Well Name: JOHN DENVER 15/14 FED COM	Well Location: T18S / R29E / SEC 15 / SWSW /	County or Parish/State: /
Well Number: 528H	Type of Well: OIL WELL	Allottee or Tribe Name:
Lease Number: NMNM0437524	Unit or CA Name:	Unit or CA Number:
US Well Number: 3001554413	Well Status: Drilling Well	Operator: MEWBOURNE OIL COMPANY

Sundry ID: 2762961

Type of Action: APD Change

Mewbourne Oil Company request that the following change be made to the John Denver 15/14 B2MP Fed Com #1H (APD ID # 10400084743):

Figure 1. BOP diagram

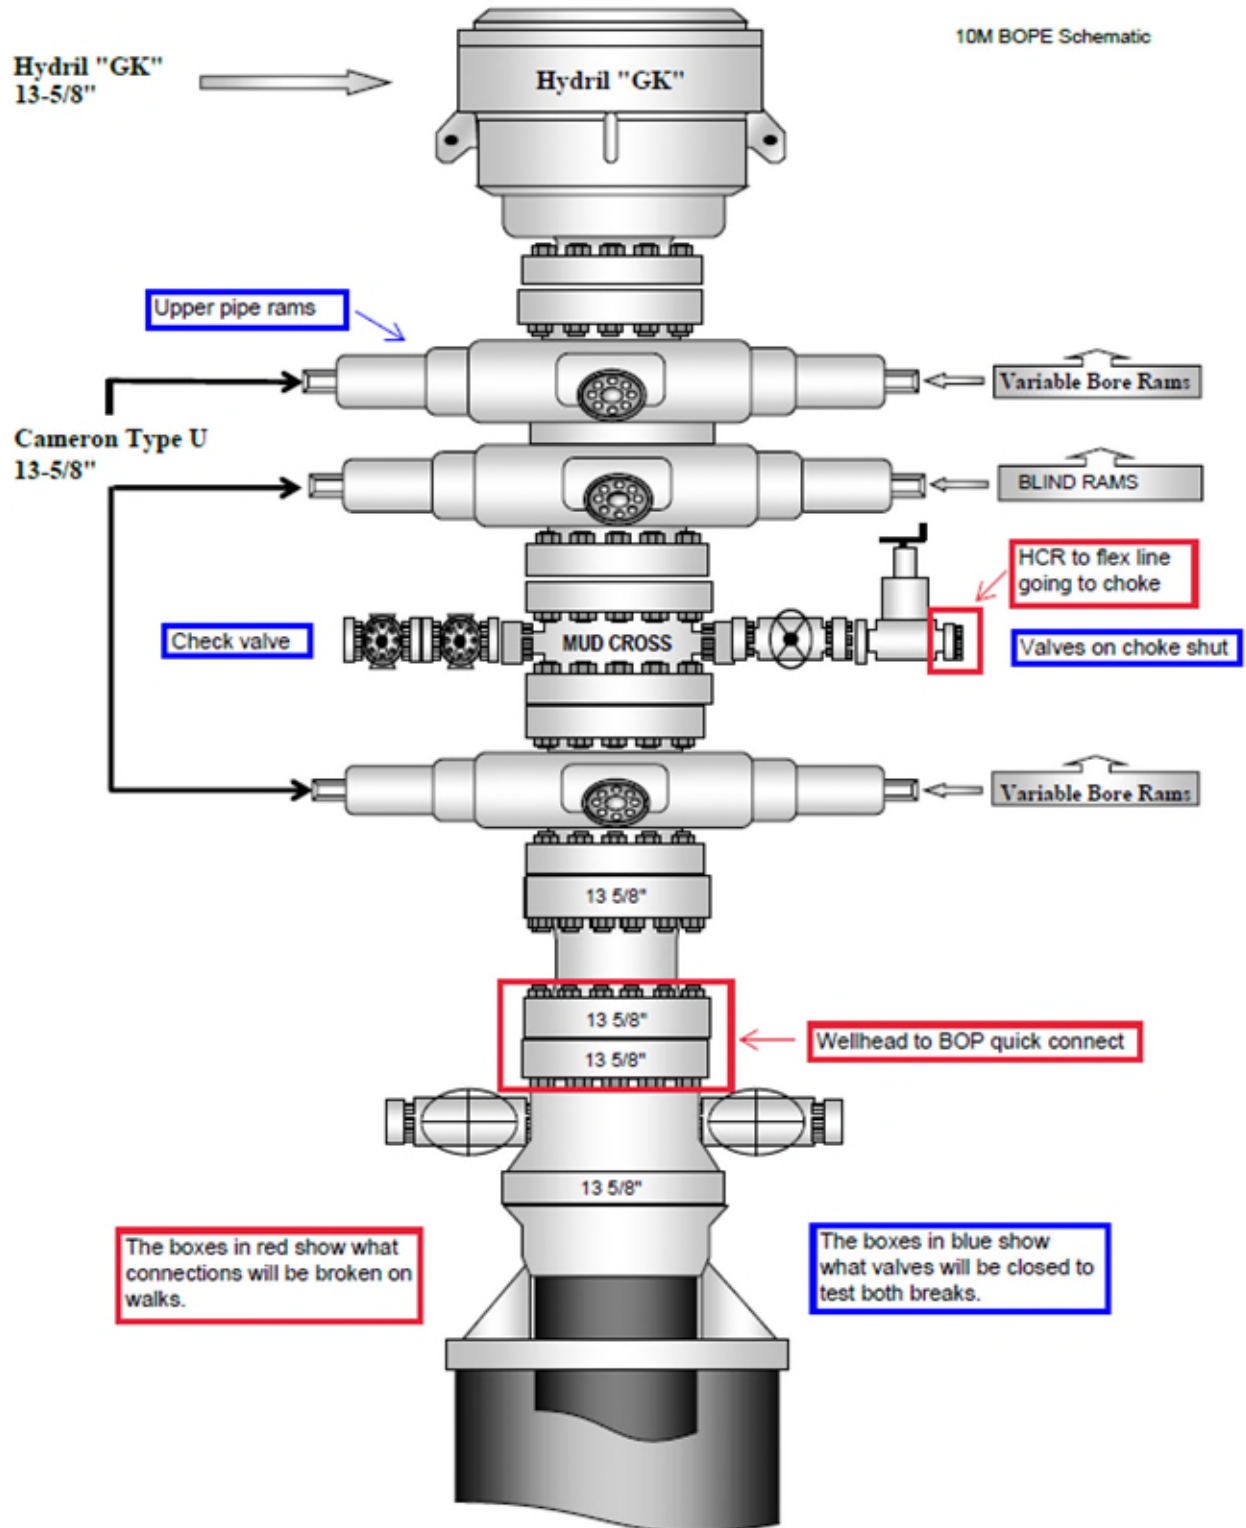
2. After the well section is secured and the well is confirmed to be static, the BOP will be disconnected from the wellhead and walked with the rig to another well on the pad. Two breaks on the BOPE will be made (Fig. 1).

9. A test will then be conducted against the upper pipe rams and choke, testing both breaks (Fig. 1 & 2).
10. The test will be held at 250 psi low and to the high value submitted in the APD, not to exceed 5000 psi.

Figure 3. BOP handling system

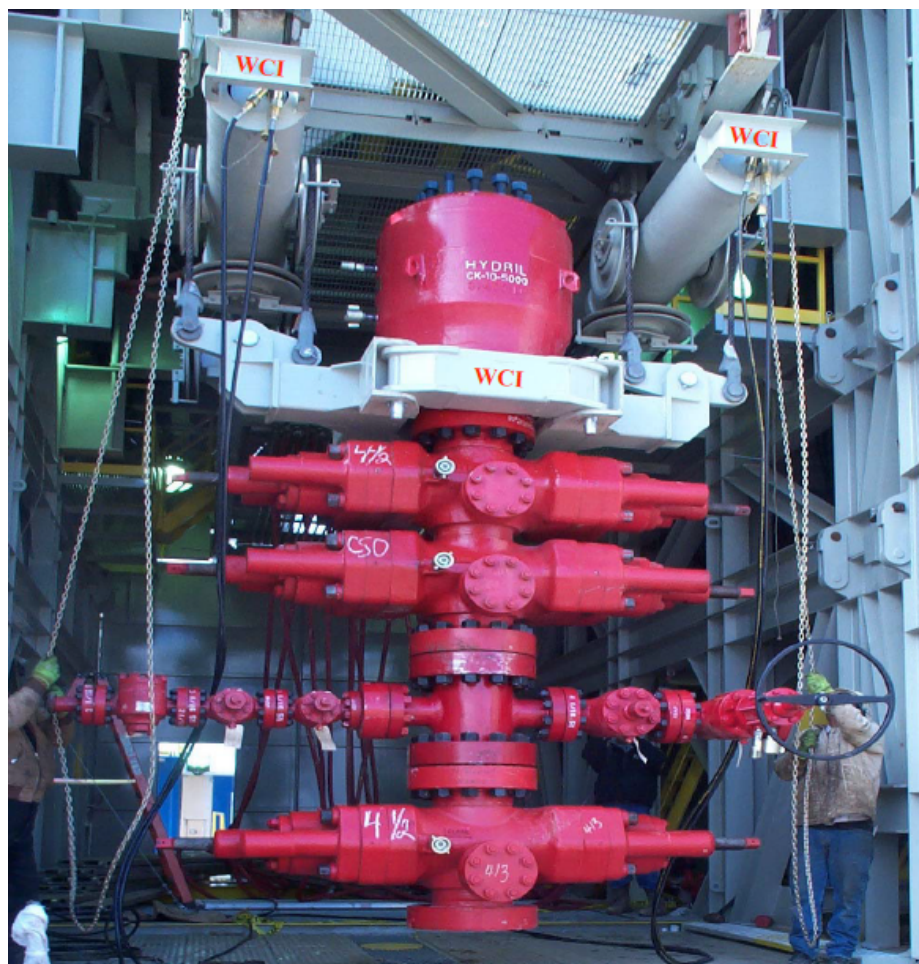
4. The BOP will be removed and carried by a hydraulic carrier (Fig. 3 & 4).
5. The rig will then walk to the next well.
6. Confirm that the well is static and remove the capping flange.

Figure 5. Cactus 5M wellhead with BOP quick connect

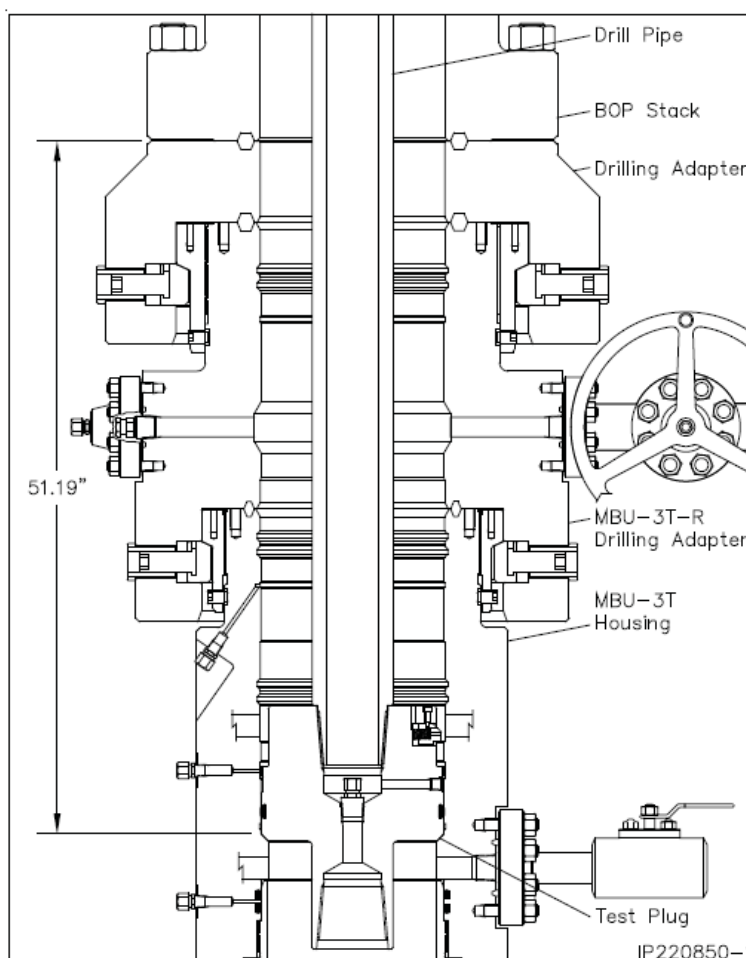
- Connection between the flex line and the HCR valve
  - Connection between the wellhead and the BOP quick connect (Fig. 5 & 6).
3. A capping flange will be installed after cementing per wellhead vendor procedure & casing pressure will be monitored via wellhead valve.

Figure 1. Cactus 13 3/8" 5M offline cementing tool. Pressure rating limited by the lesser of 5M tool rating or the 13 3/8" pup joint and casing.

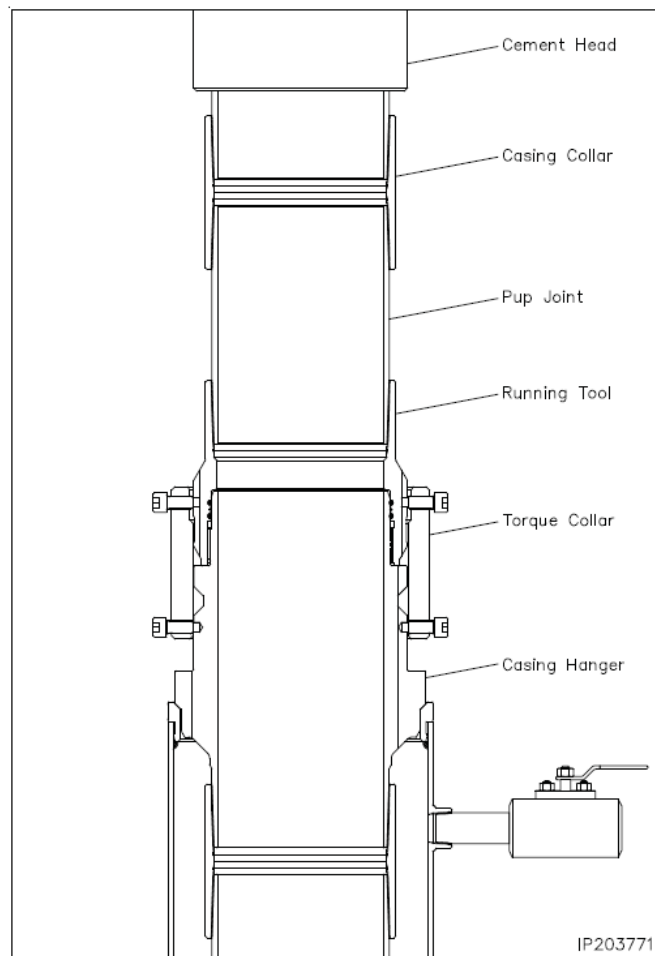
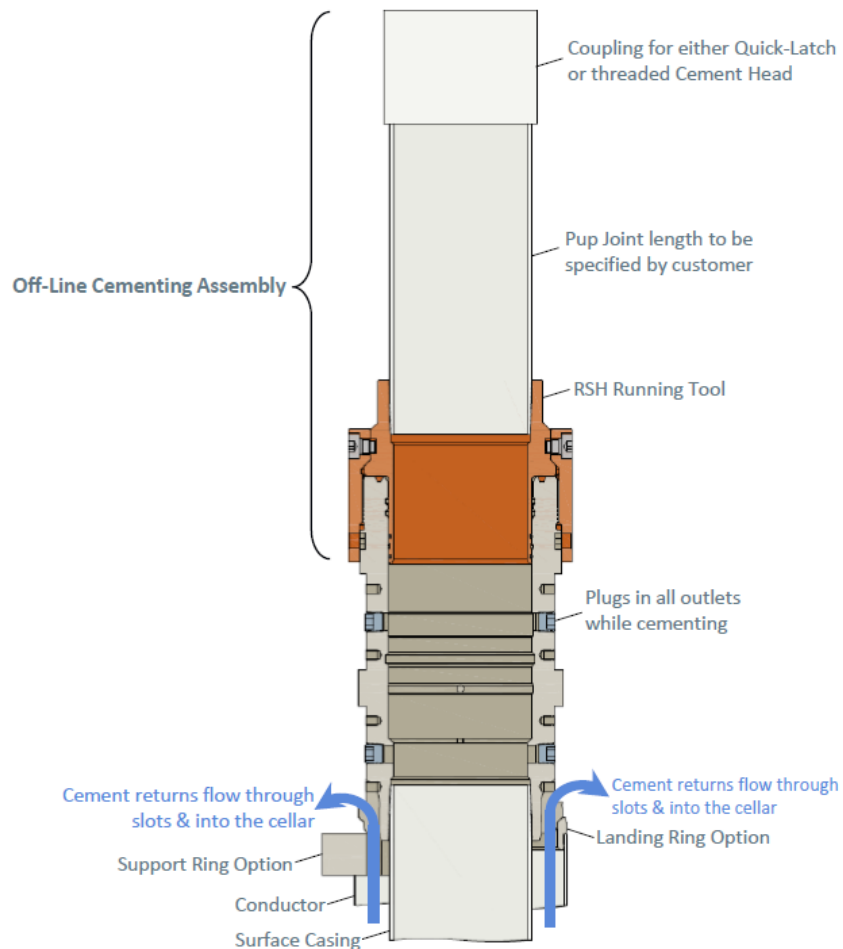
9. Make up offline cement tool with forklift per wellhead manufacturer (Fig. 1 & 2).
10. Make up cement head on top of offline cement tool with forklift.

Figure 3. Cactus 9 5/8" 5M offline cementing tool. Pressure rating limited by the lesser of 5M tool rating or the 9 5/8" pup joint and casing.

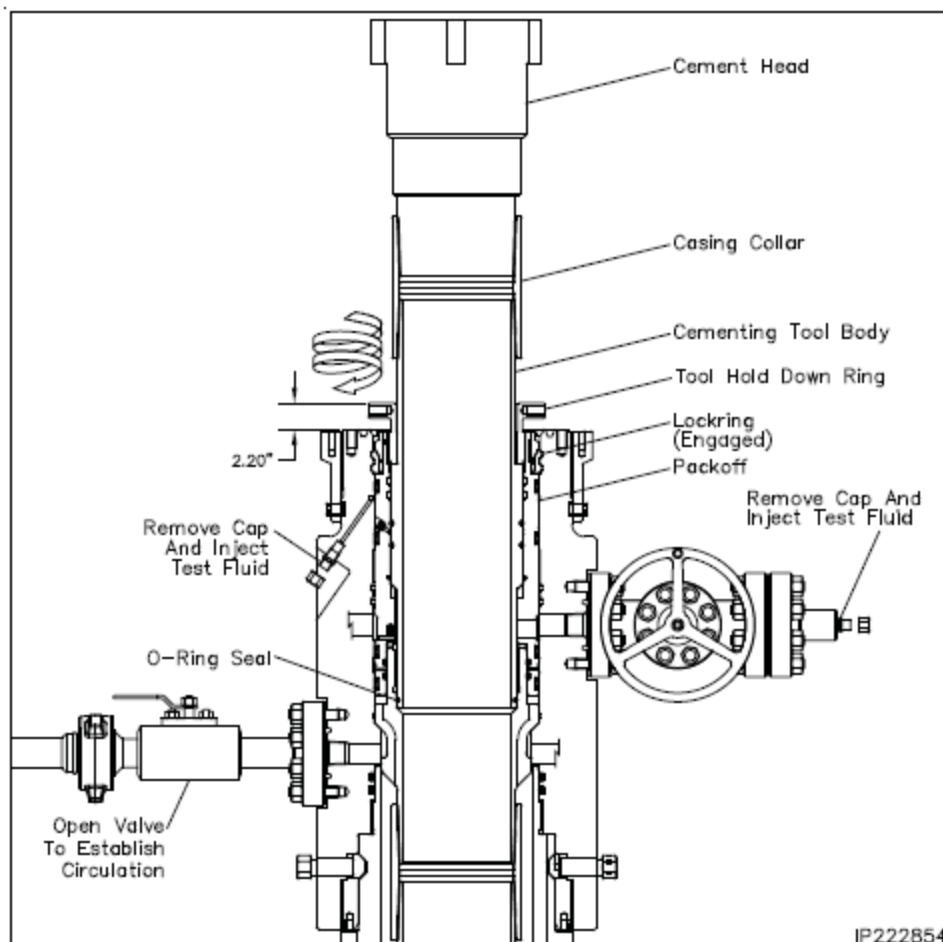
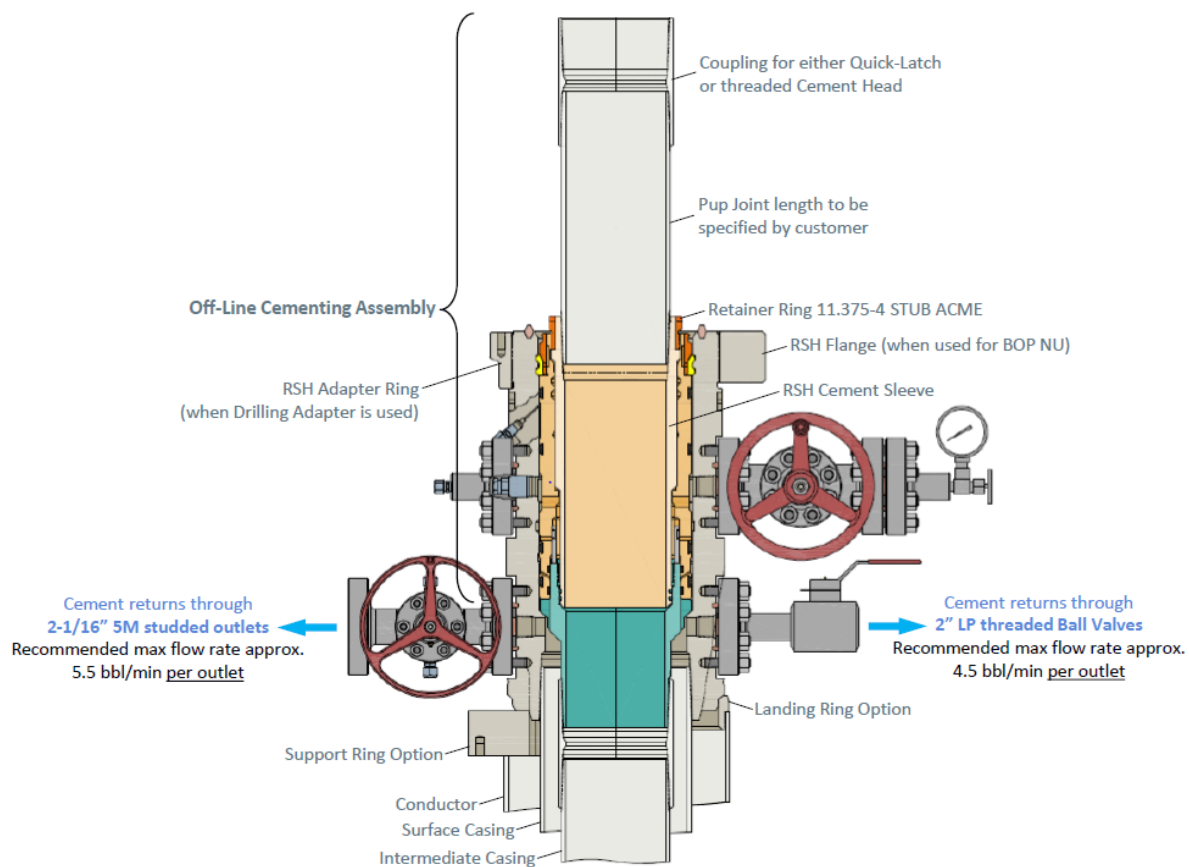
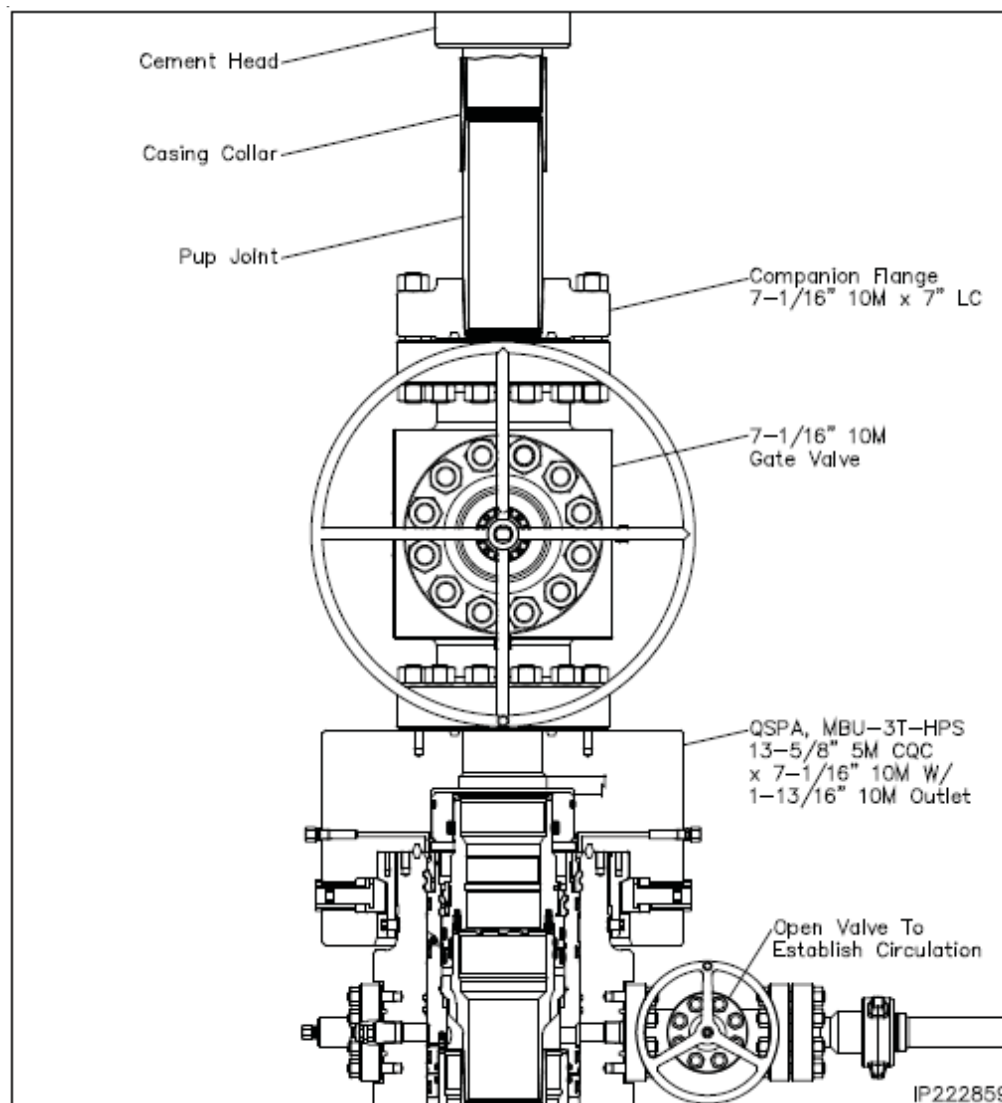
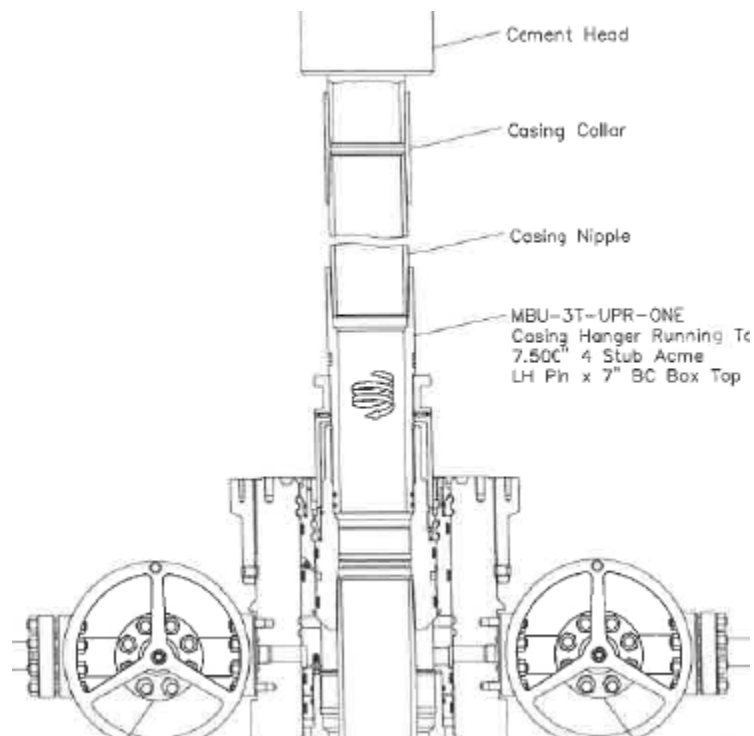
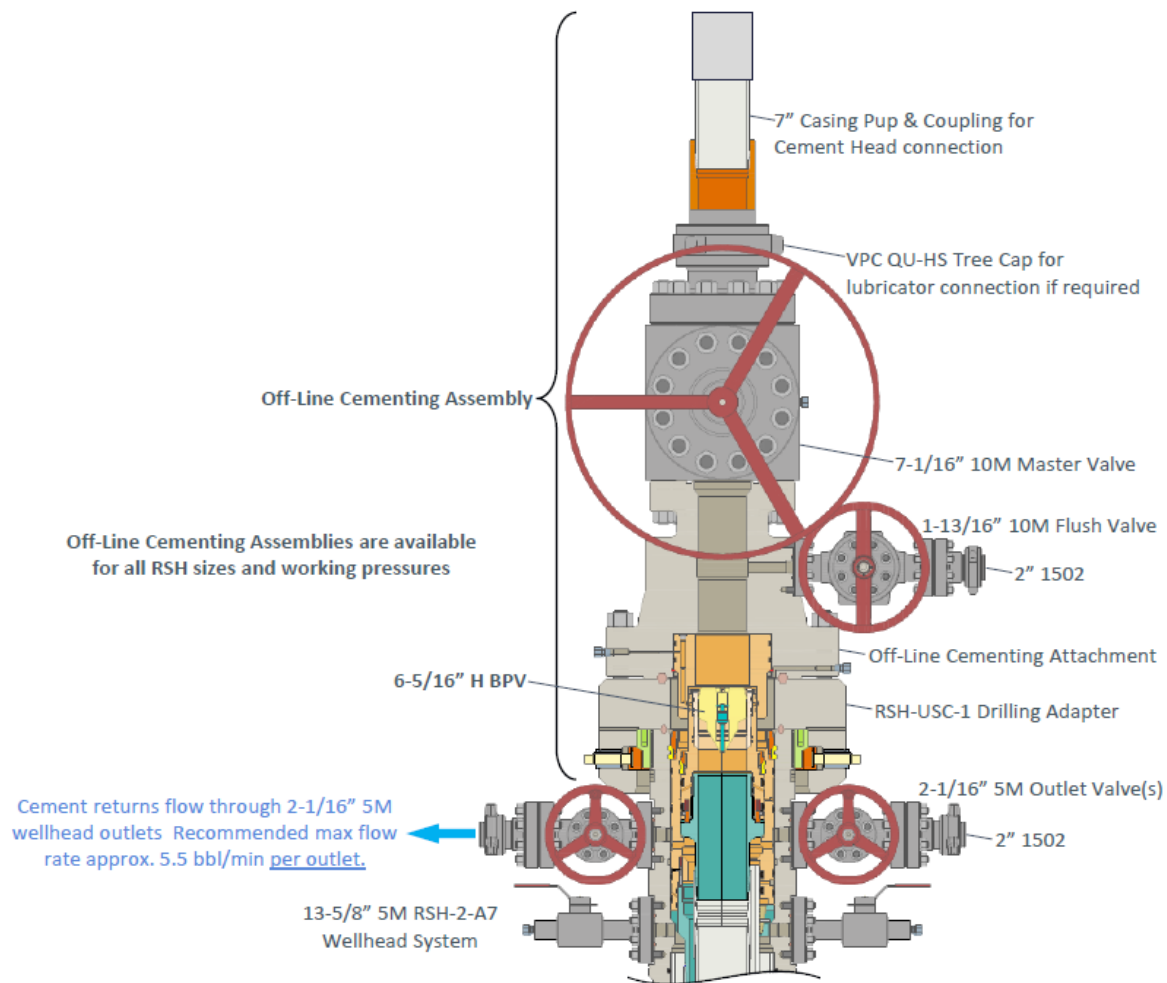
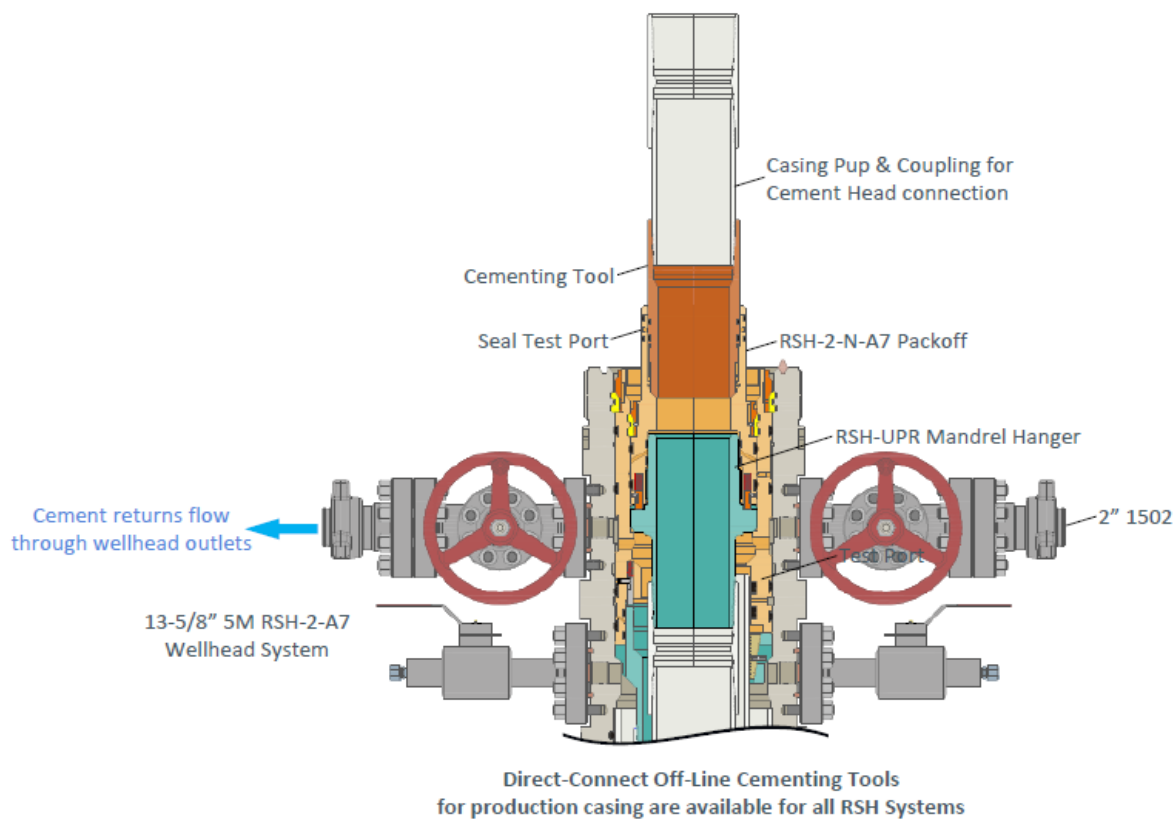
10. Make up offline cement tool using forklift per wellhead manufacturer (Fig. 3 - 8).
11. Make up cement head on top of offline cement tool.
12. Commence cement operations.
